Micro Bird Inc**SERVICE
BULLETIN****TITLE: Remedy battery drainage issues****TO: Micro Bird dealers****PRODUCT: Micro Bird buses, GM MY 2014, with lift
interlock working without Key****FROM: After Sales and Warranty department****PLANNING****Description**

Modification to the wiring is required to prevent battery drainage on Micro Bird buses built on GM chassis MY 2014 which are equipped with I40 (lift interlock without key). If parking brake stays depressed for a long period of time, the battery will drain due to the parking brake being connected to the interlock system.

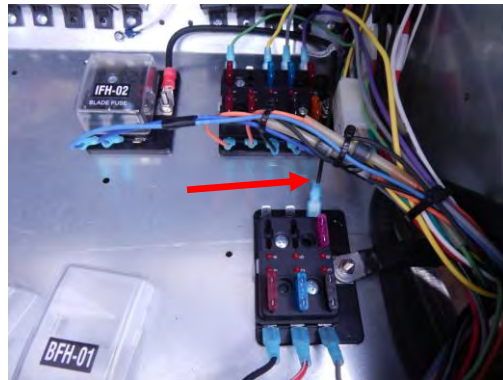
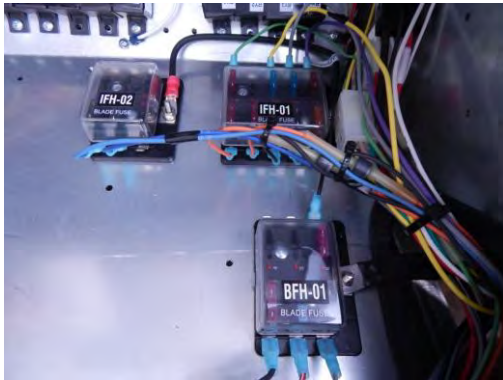
Remove the fuse holders covers (IFH-01 and BFH)

- 1- Remove both covers from the battery fuse holder (BFH) and ignition fuse holder (IFH).
- 2- Locate the black wire 16BLK228 going from relay RY10 to the BFH fuse holder.
- 3- Remove the wire and its fuse from the fuse holder.

- 4- Connect the 1 amp diode on this black wire.
- 5- Connect the diode wire in the IFH-01 fuse holder (if there is no room for an additional fuse, fix the wire into IFH-02) and insert the fuse next to it.
- 6- Re-install the fuse holder covers.
